SUBDIVISION / LAND DEVELOPMENT PLAN APPLICATION

PROJECT NAME (TO BE COMPLETED BY TOWNSHIP): The Farmhouse

PRELIMINARY / FINAL LAND DEVELOPMENT PLANS 4000 LINCOLN HIGHWAY CALN TOWNSHIP * CHESTER COUNTY * PENNSYLVANIA

The Plan proposes construction of a restaurant with a drive-through, parking areas and subsurface stormwater infiltration beds.

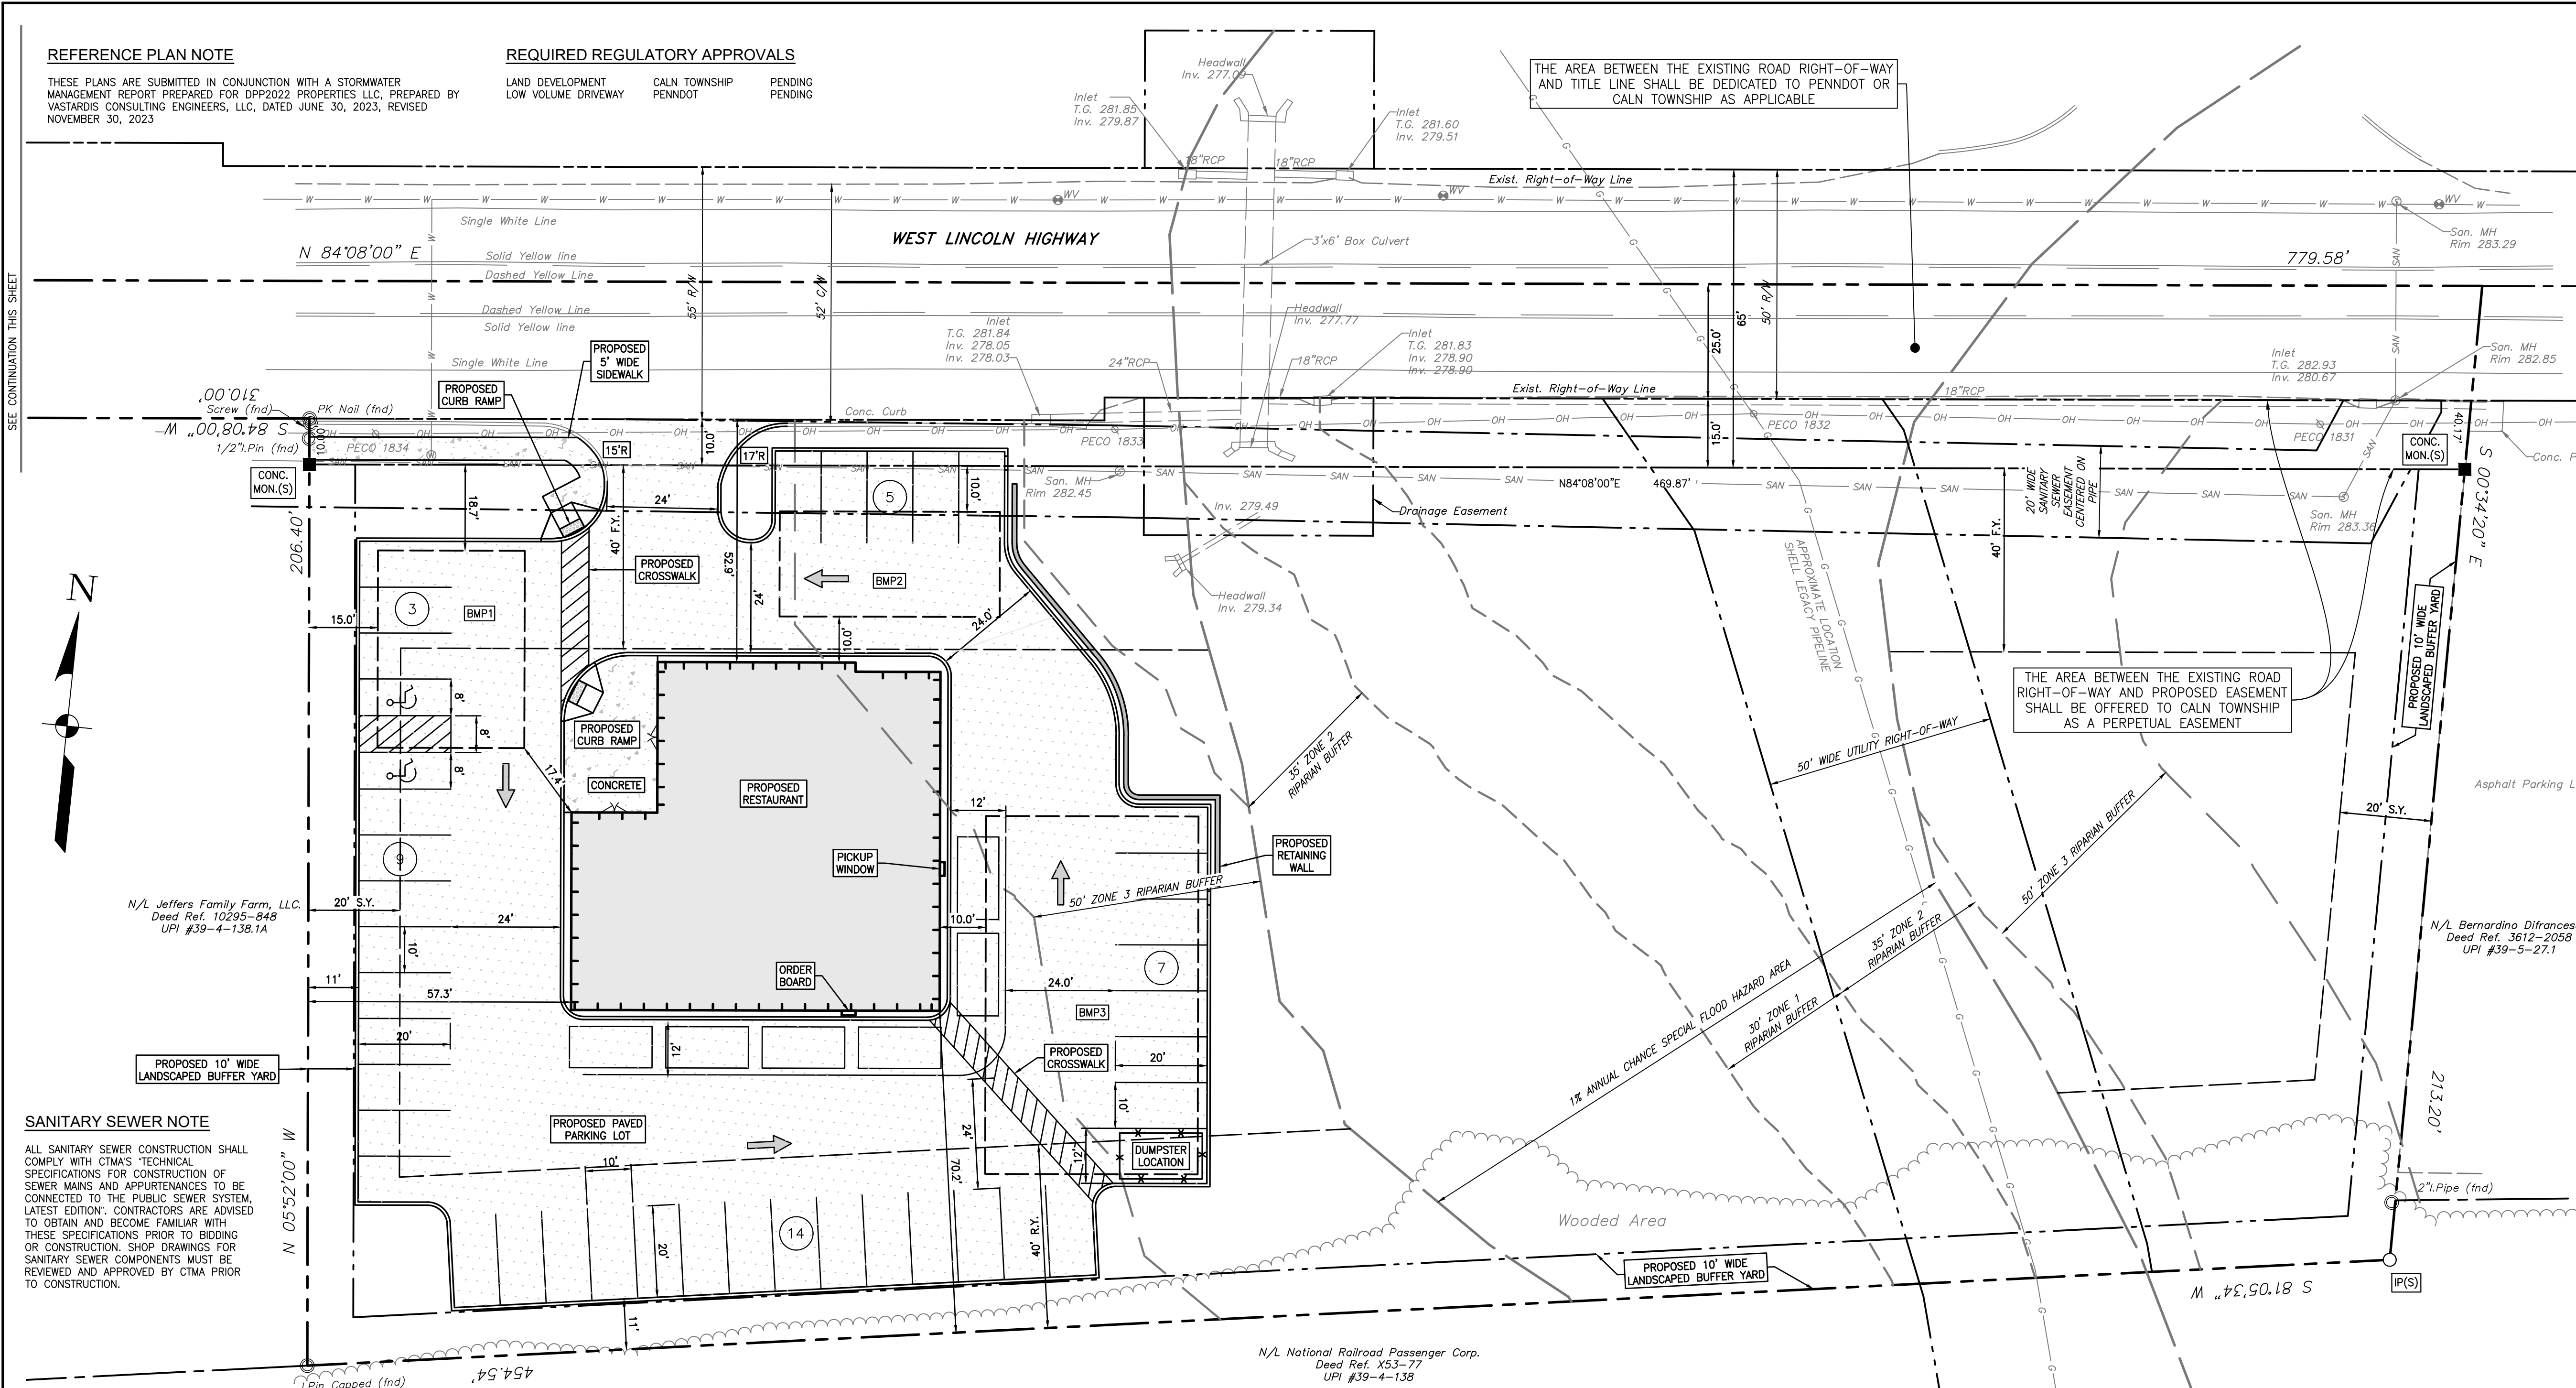
The Plan lists several waiver requests on sheet 2. A formal waiver request letter shall be provided in accordance with this section. The letter shall include the grounds and facts on which each request is based, the specific provision(s) of the ordinance involved and the minimum modification necessary.

The as-built plan note on sheet 2 shall be updated to include reference to this section of the subdivision and land development ordinance (§137-54).

LIGHTING PLAN

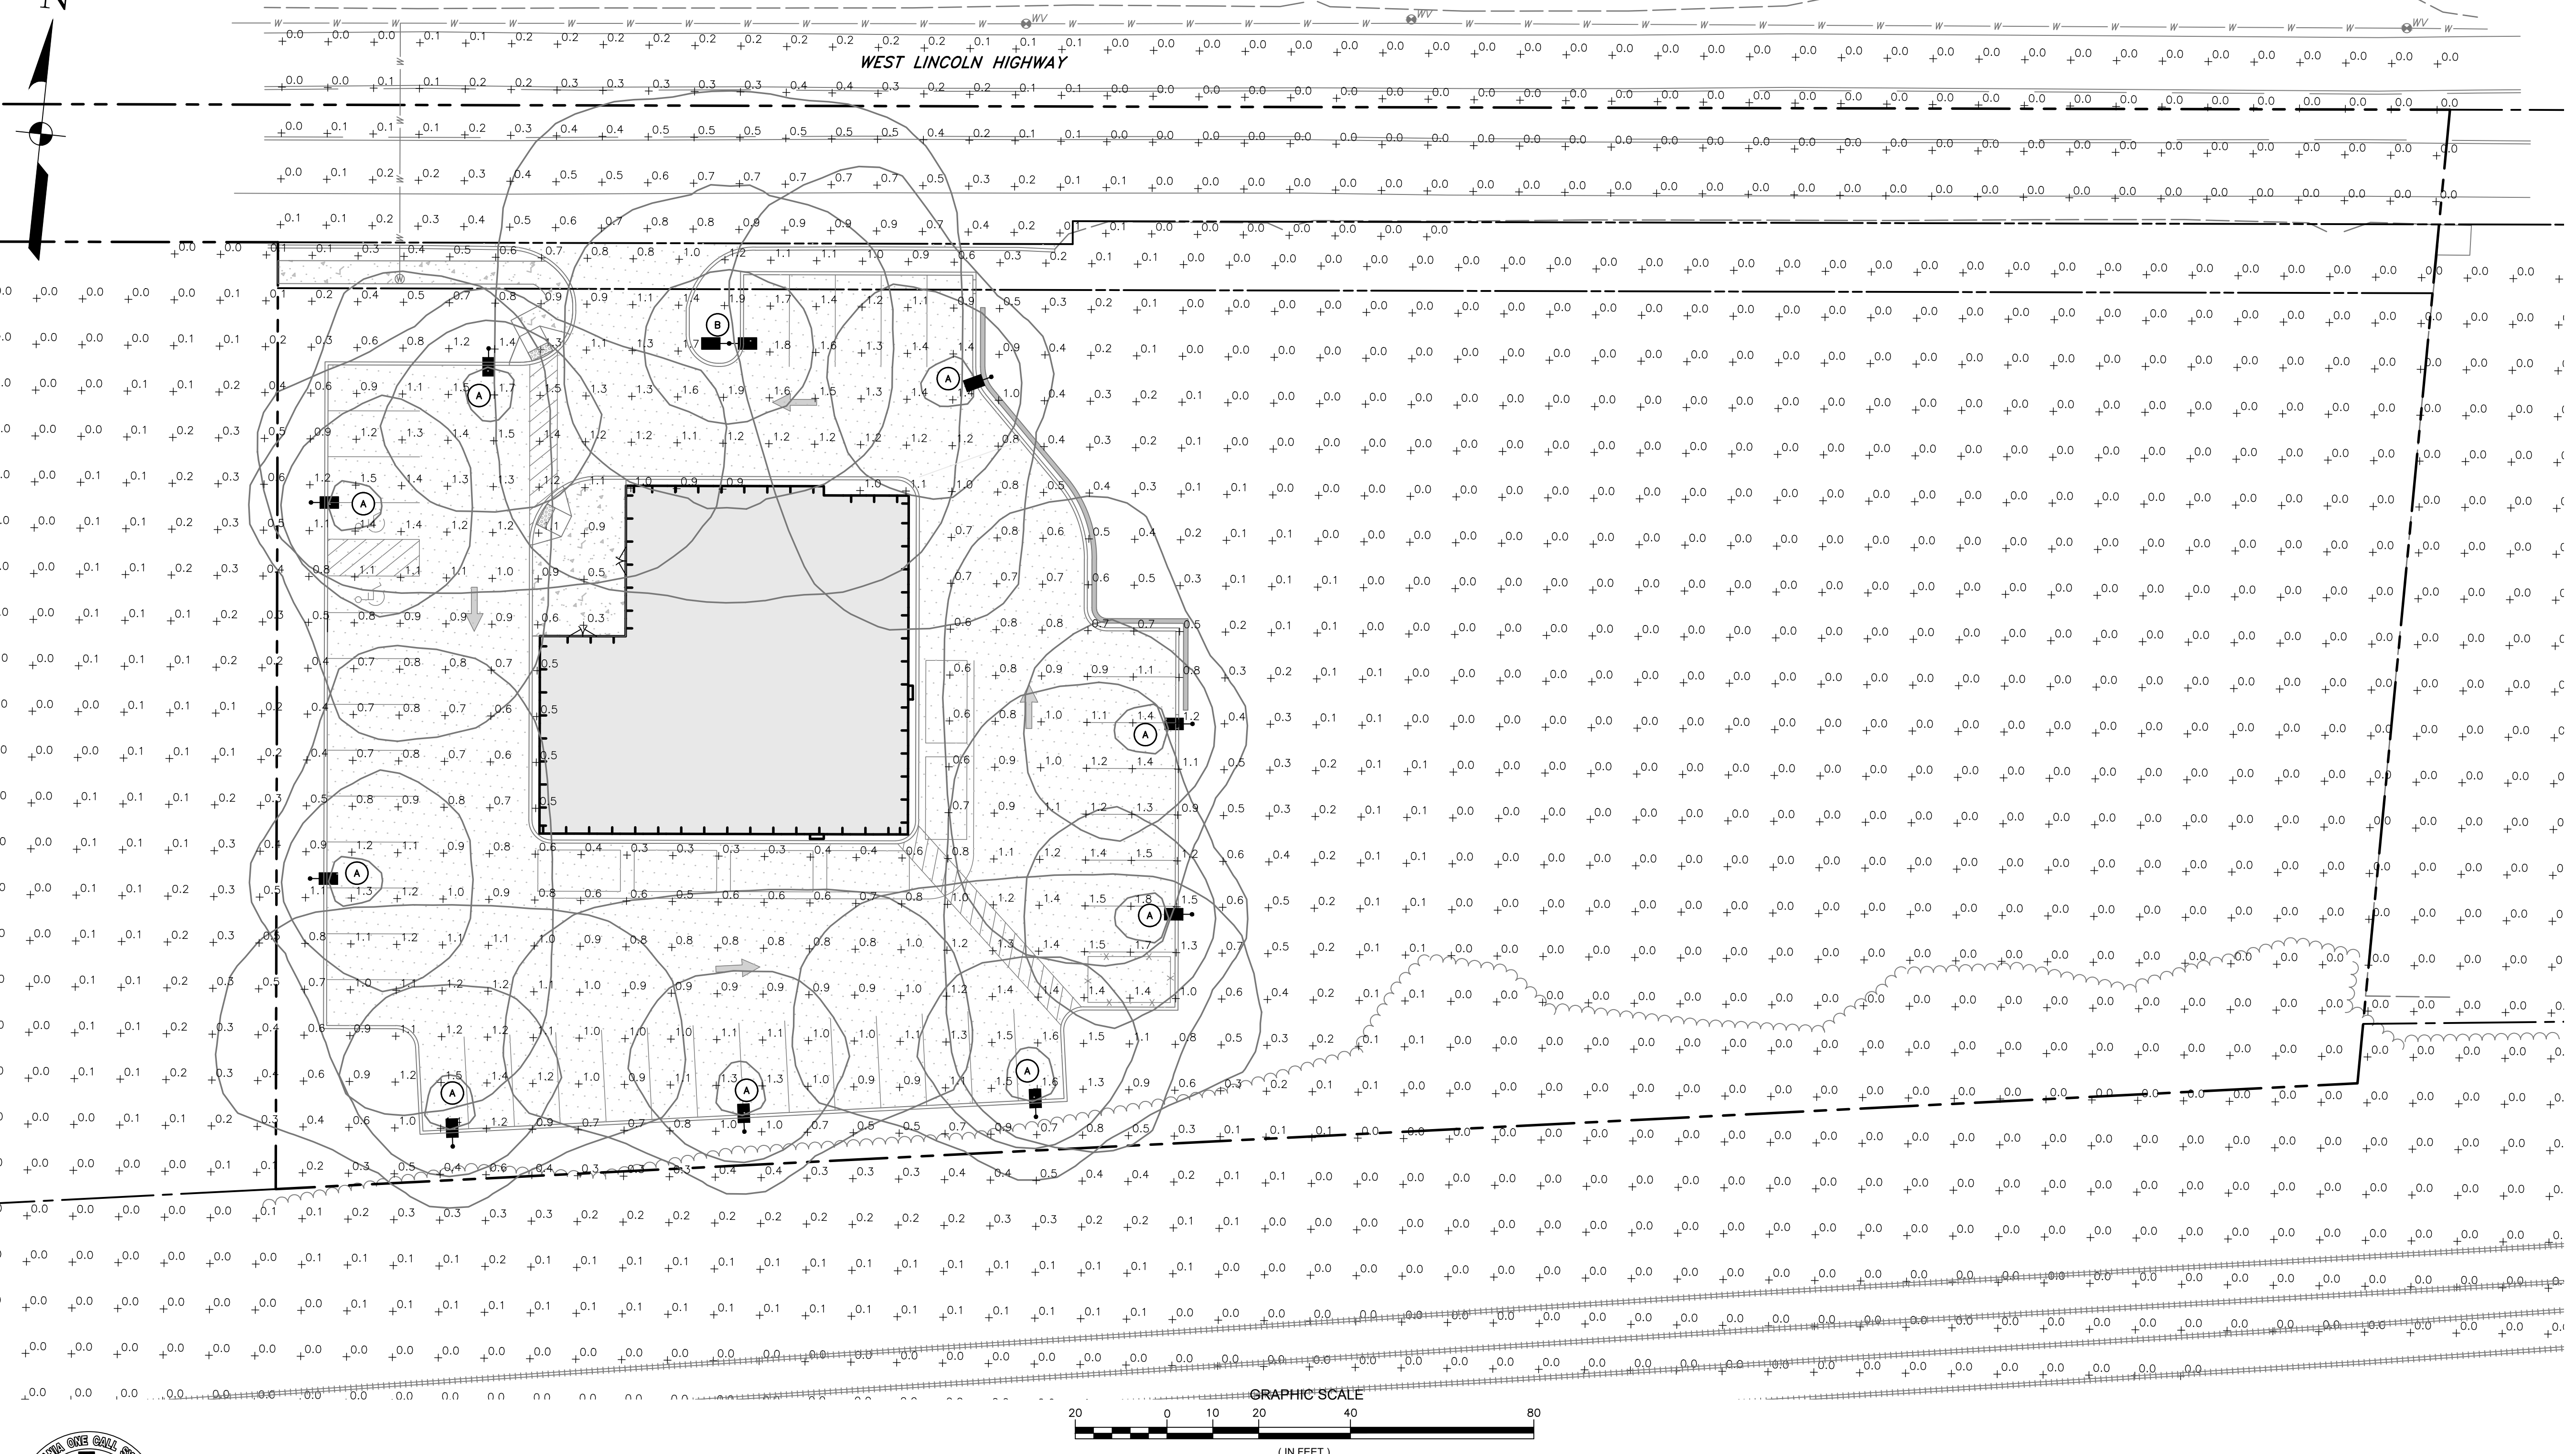
The Applicant must provide notes and/or details on the Lighting Plan to demonstrate compliance with this condition.

Details for the lighting such as catalog cuts, glare control devices, lamps, mounting heights and means, proposed hours of operation of the lighting, and maintenance schedule must be added to the Lighting Plan.
